**PALM BEACH COUNTY
PLANNING, ZONING AND BUILDING DEPARTMENT
ZONING DIVISION**

Application No.: ZV/DOA-2010-01728
Control No.: 1984-00152
Applicant: Siemens Group, Inc.
Owners: Mizner Trail Golf Club Ltd
Agent: Urban Design Kilday Studios - Wendy Tuma
Telephone No.: (561) 366-1100
Project Manager: Wendy Hernandez, Zoning Manager

TITLE: a Development Order Amendment **REQUEST:** to modify and redesignate uses, and add Pod's (Tracts), units, and access points on the Master Plan.

Figure 10 Preliminary Visual Impact Analysis dated September 27, 2010 pages 1 of 6

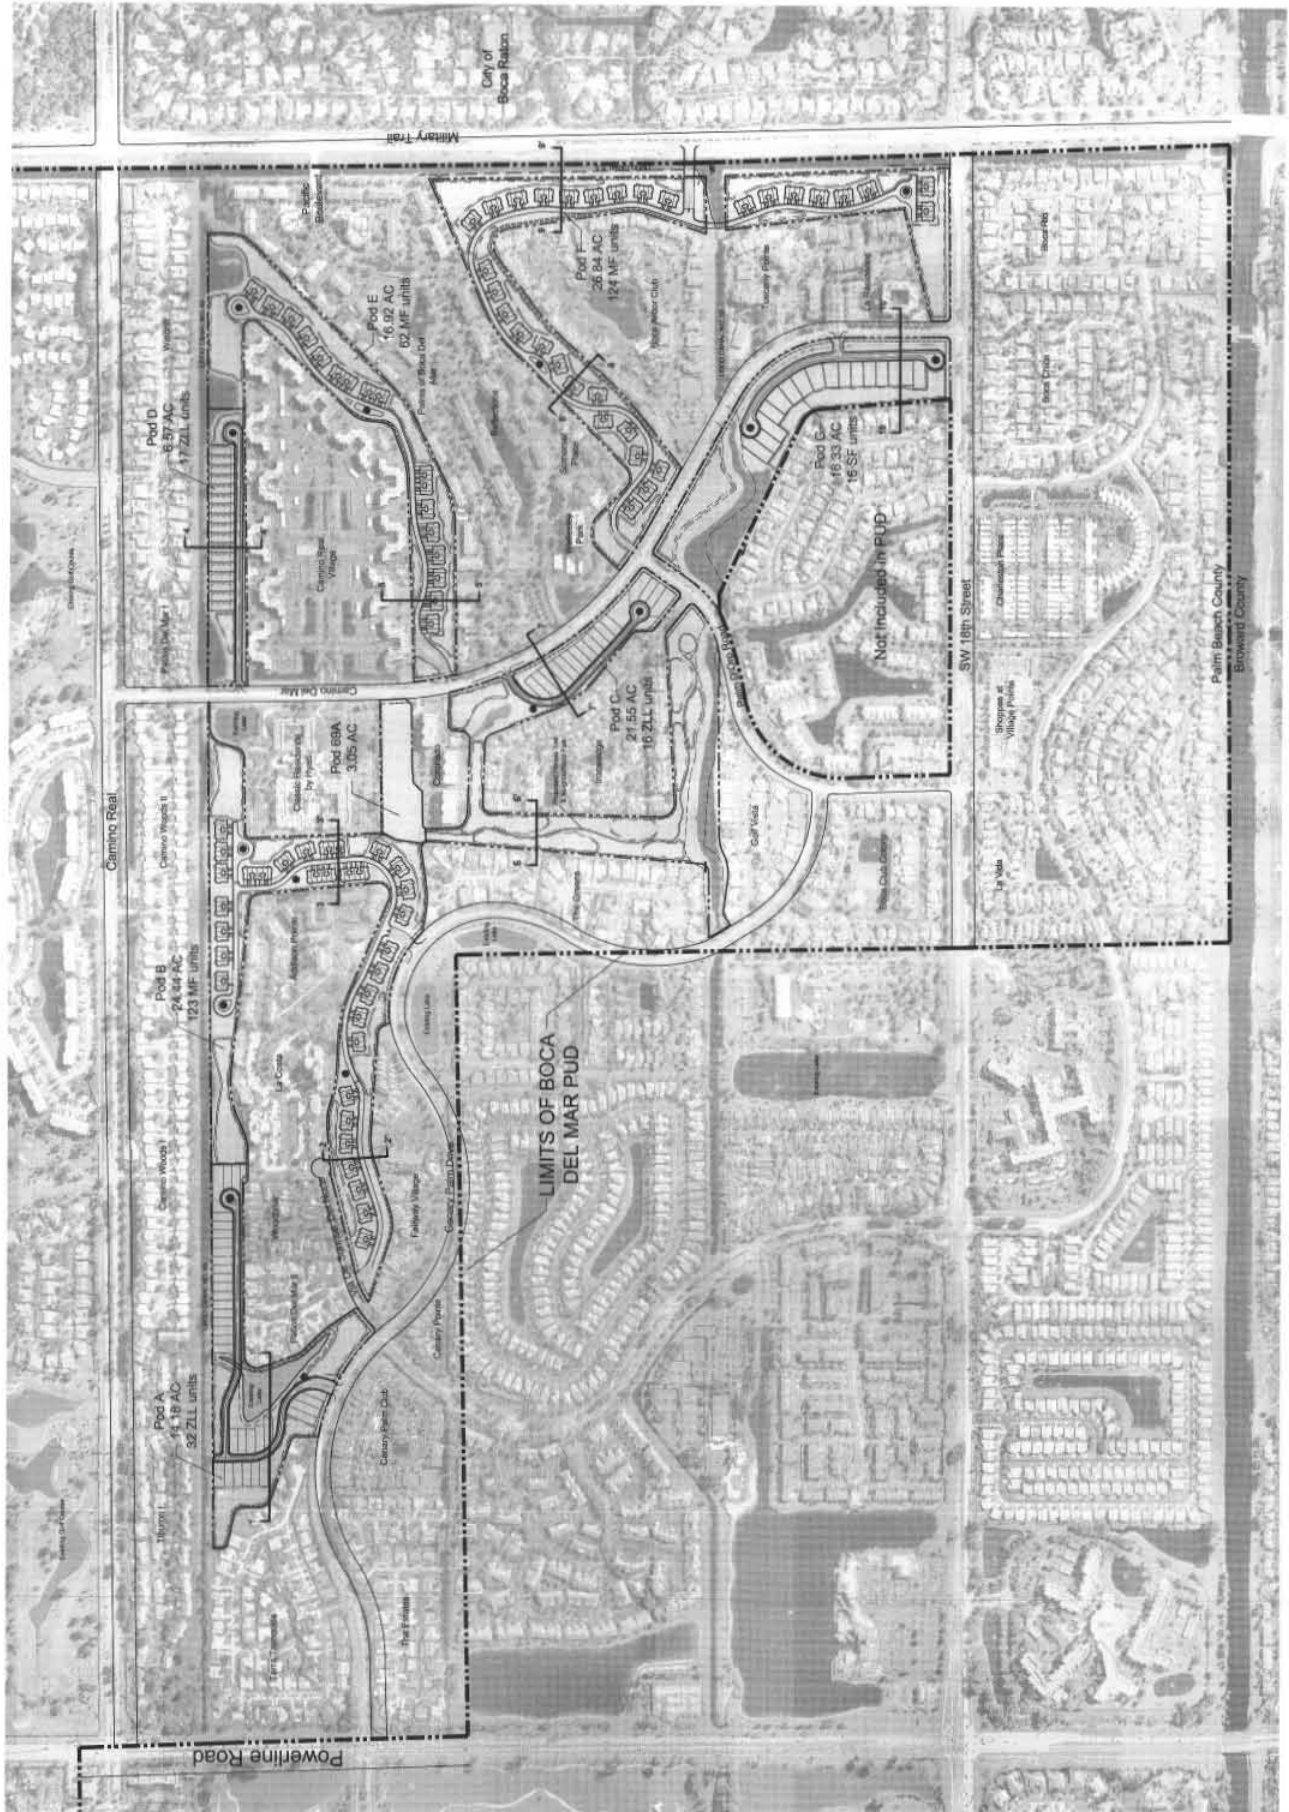
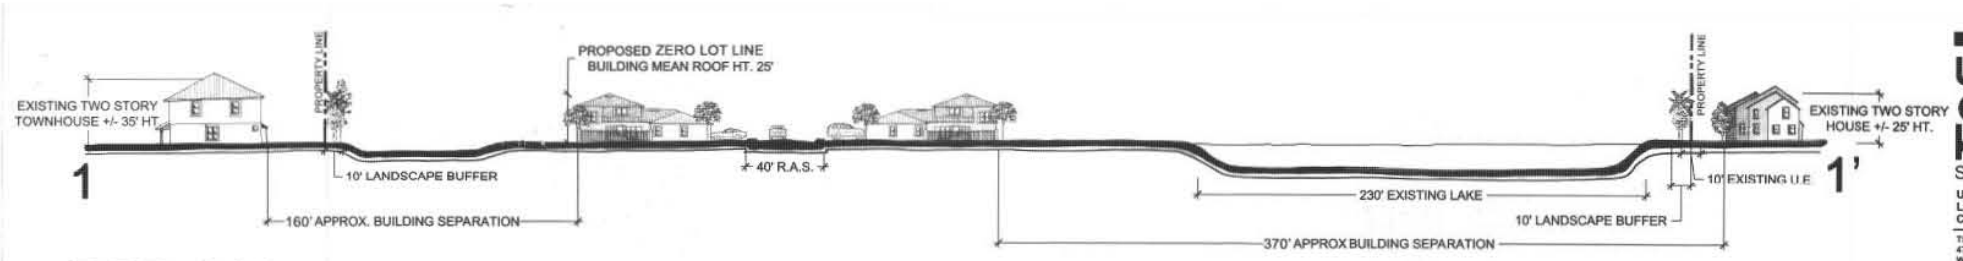
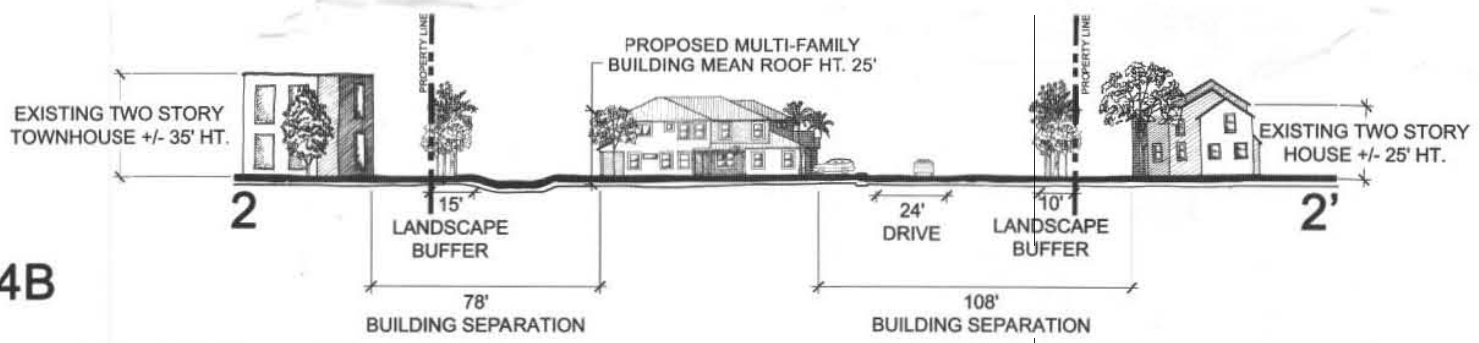
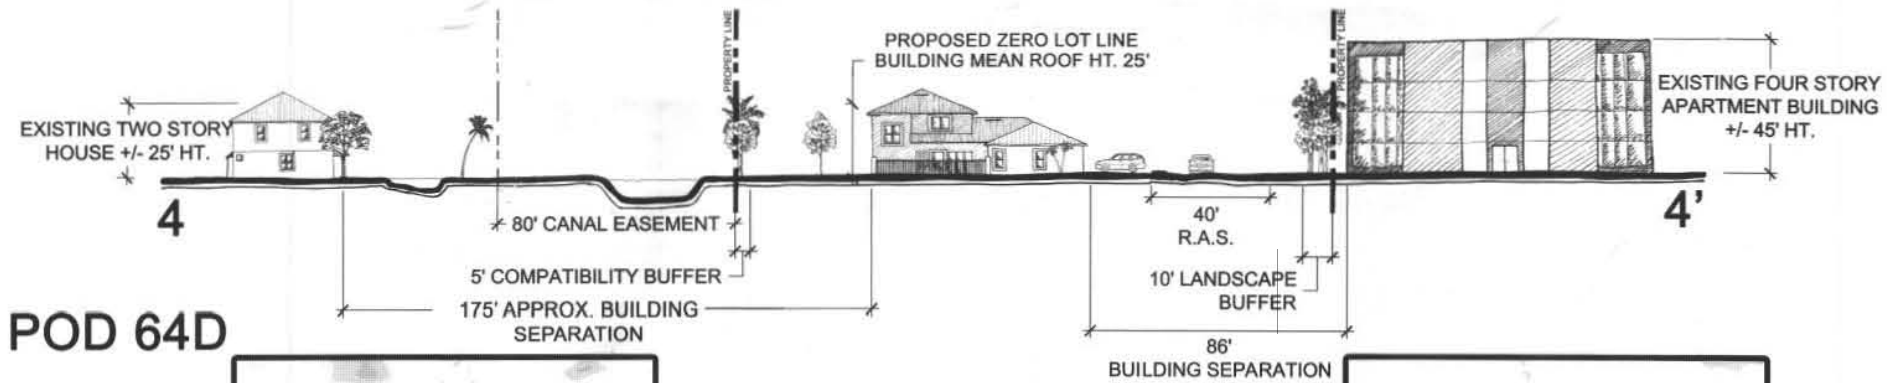
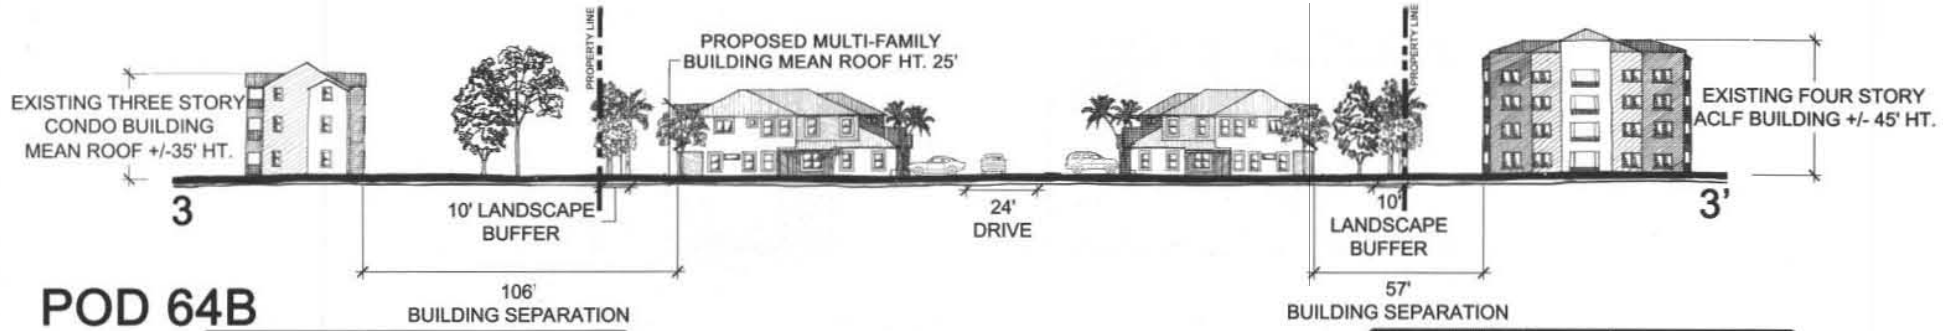
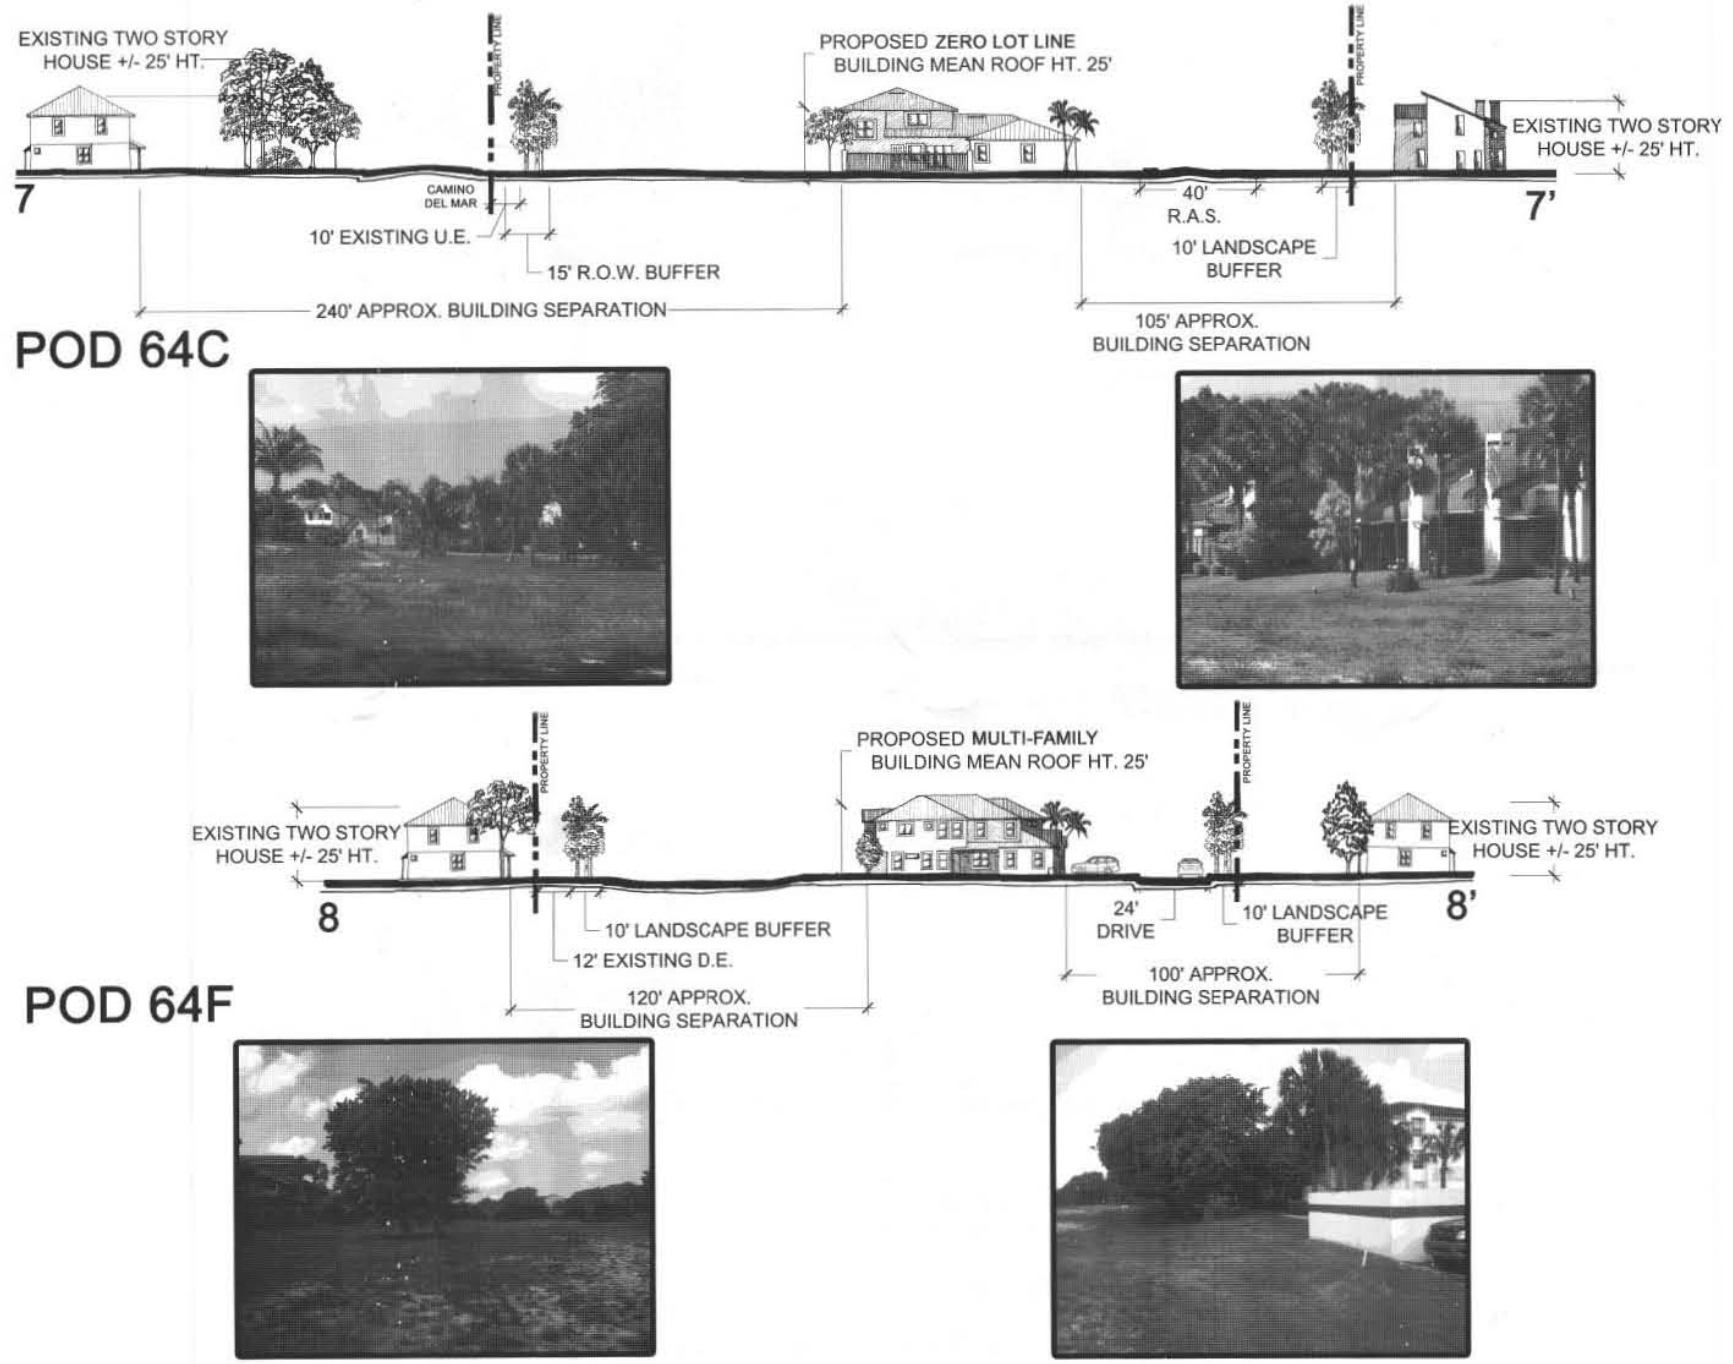
residential units due to the narrow configuration of each pod. As seen in the Figure 9, the Preliminary Site/Subdivision Plan and the Figure 10 Visual Impact Analysis, these graphics clearly indicate that the applicant is creating new roads, each of which ends in cul-de-sacs.

In the Justification Statement, the applicant indicates that the plans that he submitted were based upon the analysis of the building types and placement of the existing structures. However, the Justification Statement does not support his assertion that the VIA depicts limited impact on the surrounding neighborhoods. On January 28, 2011, the applicant submitted a revised VIA plan with additional notes depicted the proposed layout to demonstrate that either there is no impact or all potential negative visual impact has been addressed through the placement of buildings or provision of open space. In staff's opinion, it provided additional information on where the applicant believes the impacts are; however, staff cannot conclude from the revised VIA that overall layout and design will not have an impact on the adjacent property owners.

Although the installation of landscaping, buffering, and screening enhancements along perimeter site boundaries is typically an appropriate method of mitigating visual impacts, the proposed site plans do not utilize these tools sufficiently enough to accomplish the objectives in part, because the existing developments do not incorporate the same buffers. Furthermore, the physical constraints of the site, with its long, narrow configuration and central placement throughout the community make it difficult to provide a sufficient reduction in impact, while still achieving the intensity of use proposed by the applicant.
